City of Prescott
Prescott Preservation Commission

November 14, 2025 | 9:00 AM
201 N. Montezuma Street
Council Chambers, 1st Floor
Prescott, AZ 86301

Re: Design Review of proposed Doc's BBQ signage and patio addition at 202 South Montezuma Street (APN 109-02-046A), Prescott, Yavapai County, Arizona.

TO: MAYOR AND CITY COUNCIL
AGENDA: November 14 Prescott Preservation Commission Meeting
DATE: November 14, 2025
DEPT: Community Development
ITEM #: 3.C
SUBJECT: **HP25-008:** A Request for a New Wall with Fencing and Patio Cover at Doc's BBQ & Whiskey. Location: 202 S Montezuma St. Owner: Montezuma Goodwin LLC. Applicant: Kenneth Mohn Architect.

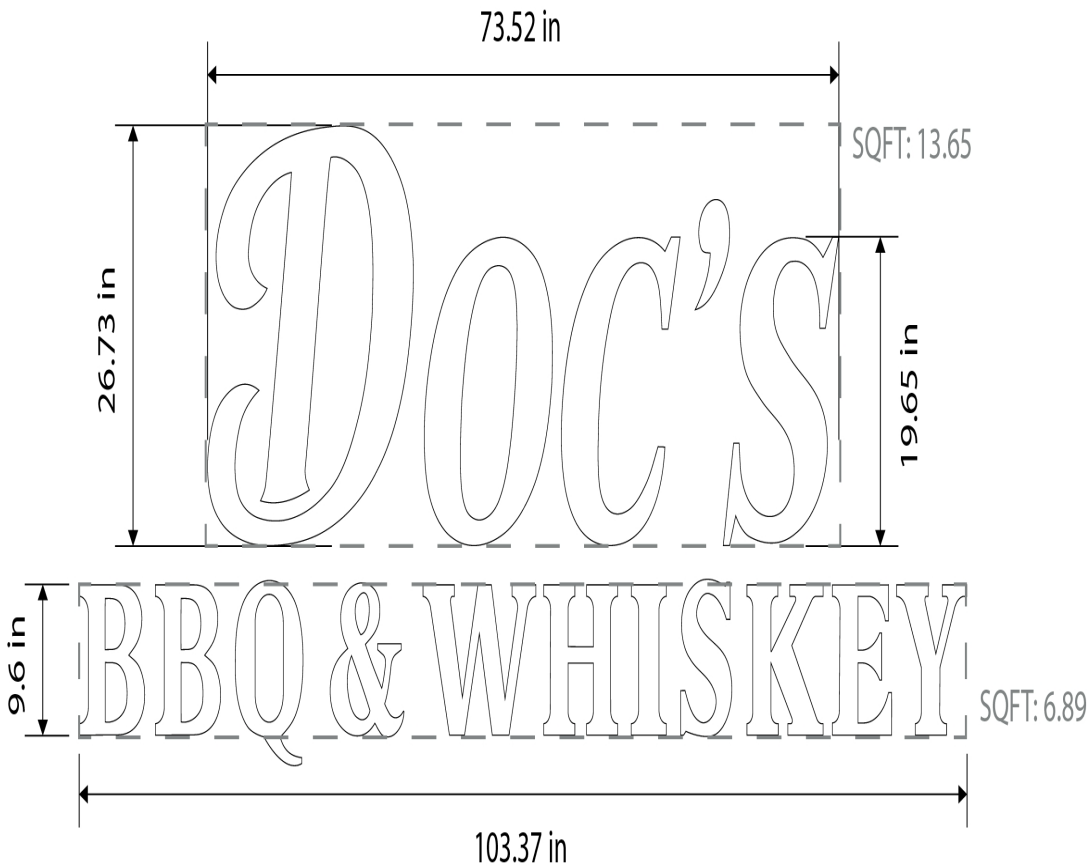
A more formal analysis has been completed by a third-party reviewer, Broadbent and Associates, Inc. and is included in your packet. Please note, this analysis includes review of additional items at this site included under record HP25-008 (next on PPC's agenda). The analysis of the signage begins on page 3 of Broadbent's report.

Site Plan	
Project number	2025-25
Date	10 16 2025
Drawn by	KMA
Checked by	KMA
A0	
Scale	1" = 10'-0"

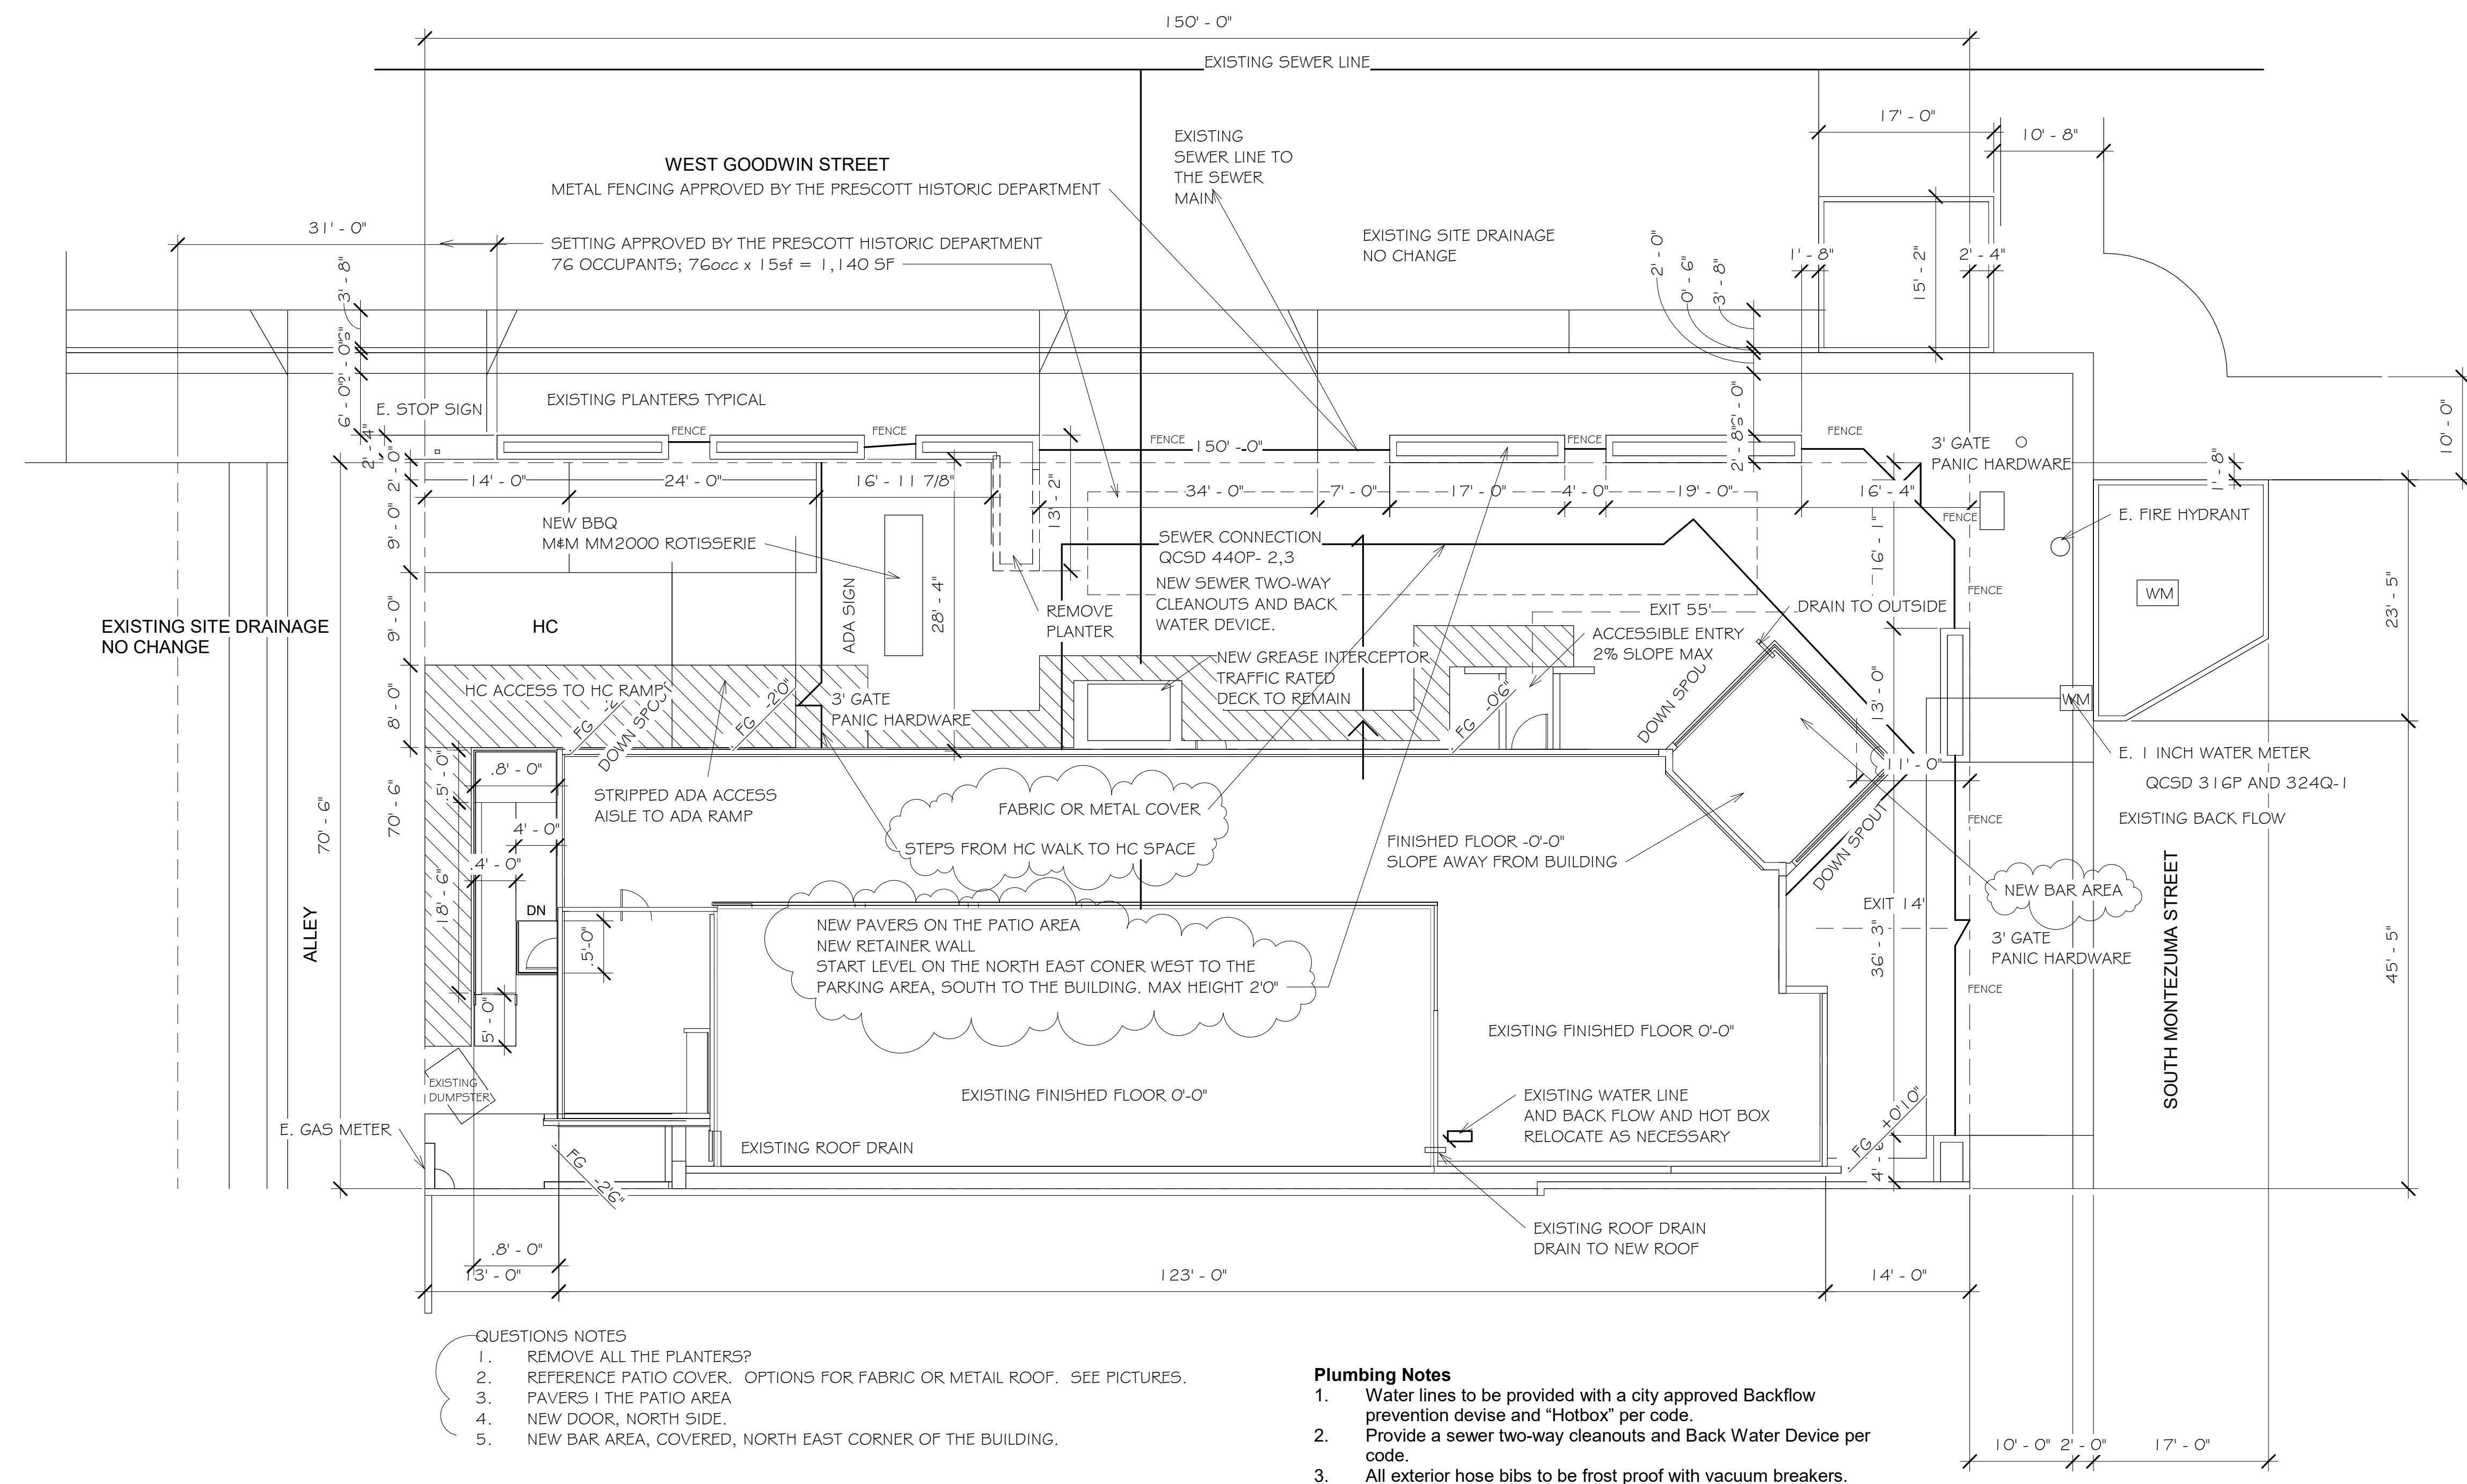
- QUESTIONS NOTES**
1. REMOVE ALL THE PLANTERS?
 2. REFERENCE PATIO COVER. OPTIONS FOR FABRIC OR METAL ROOF. SEE PICTURES.
 3. PAVERS I THE PATIO AREA
 4. NEW DOOR, NORTH SIDE.
 5. NEW BAR AREA, COVERED, NORTH EAST CORNER OF THE BUILDING.

MOVE to approve or deny HP25-008 with or without the recommended condition requiring the applicant to separate the patio covering into two sections rather than having it wrap around the northeast corner of the building

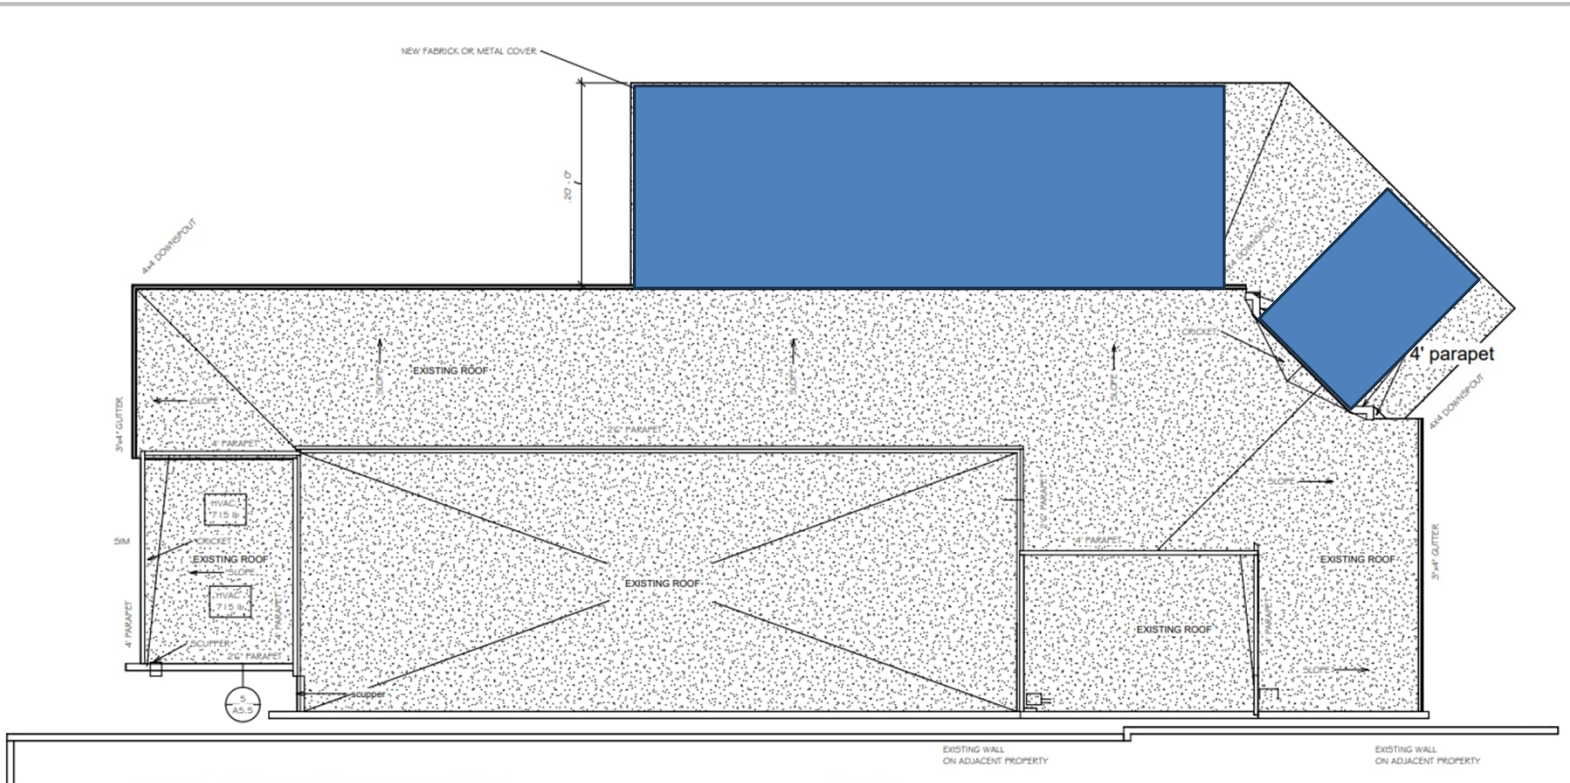
Fence and Planters approved May of 2022 by PPC but never completed.

Proposed patio cover to be black standing-seam metal.
